DA/20/0811: 8.3 REVIEW OF DETERMINATION

CONSTRUCTION OF AN ANCILLARY CAR WASH FACILITY AND SIGNAGE ASSOCIATED WITH AN EXISTING SERVICE STATION DEVELOPMENT

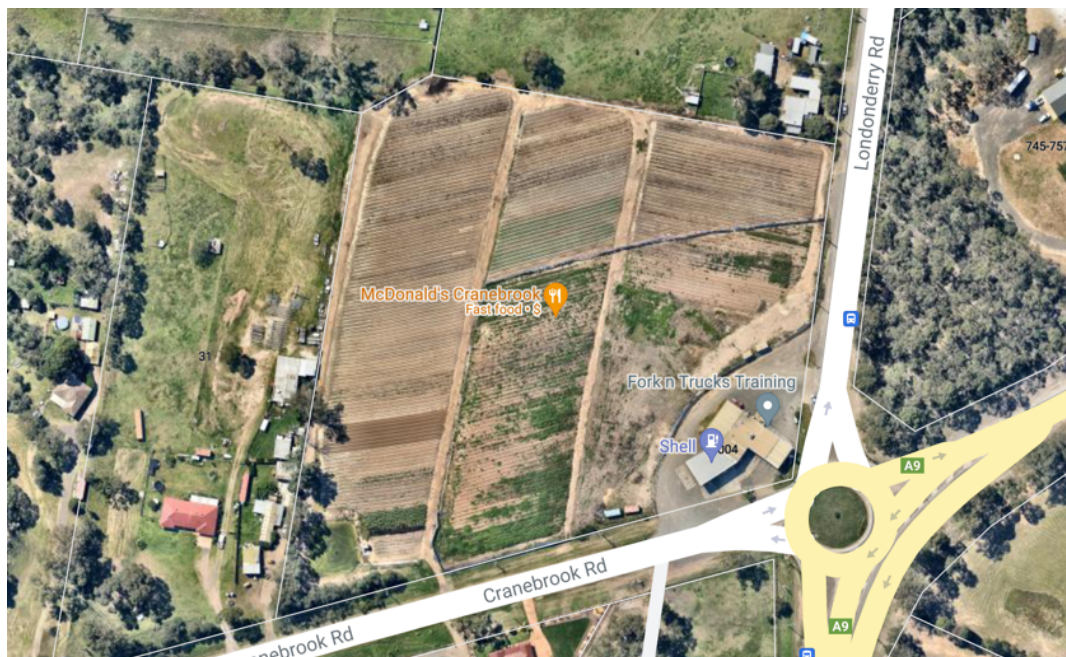
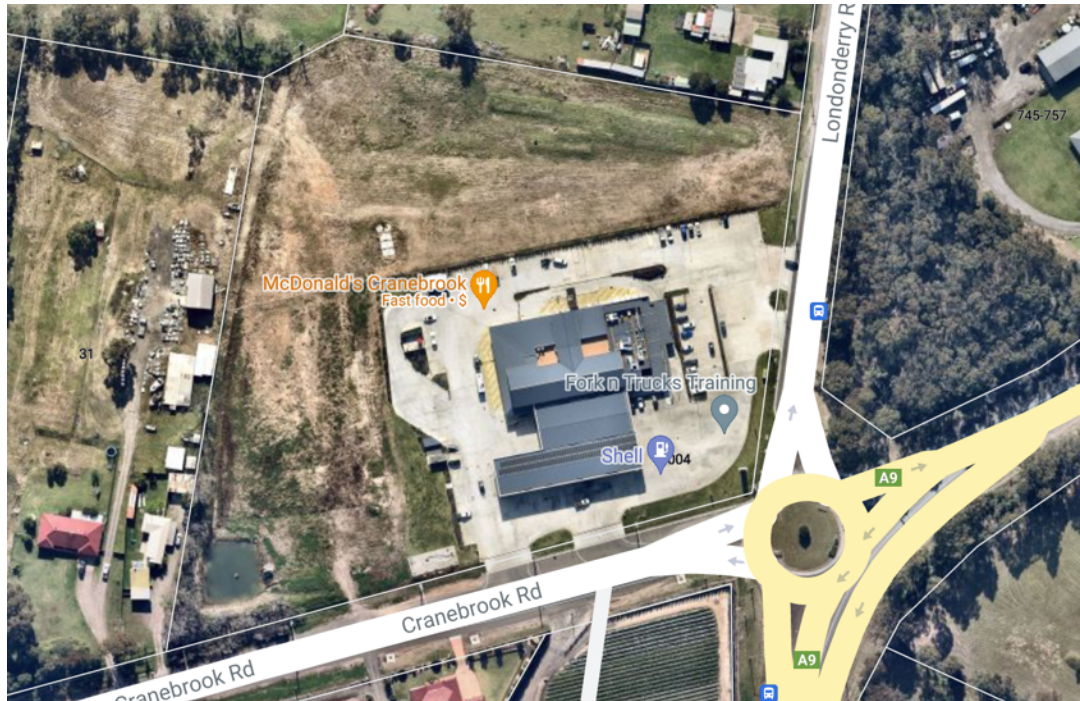
Whilst the proposal is mapped as containing scenic character and landscape values this would likely arise from the prior state of the site when the mapping was done in 2015- see the aerial photographs below for the ‘before’ (2015) and ‘after’ (2021) development outcomes. The former site configuration possessed rural elements- which are clearly all now gone with the redevelopment of the site.

So whilst the Clause applies it has limited relevance and in relation to the provisions:

- The location and design concentrates the building in proximity to the existing built form;
- The setbacks are considered suitable with additional screen planting;
- The proposal, in and of itself, won't have any discernible visual impact relative to what is existing on the site.
- We note that the site is cleared of vegetation and adopts a series of built forms atypical in the RU4 zone which is reflective of the unique site attributes and the EUR such that the relevance of the clause is low in the context of what is on the site.
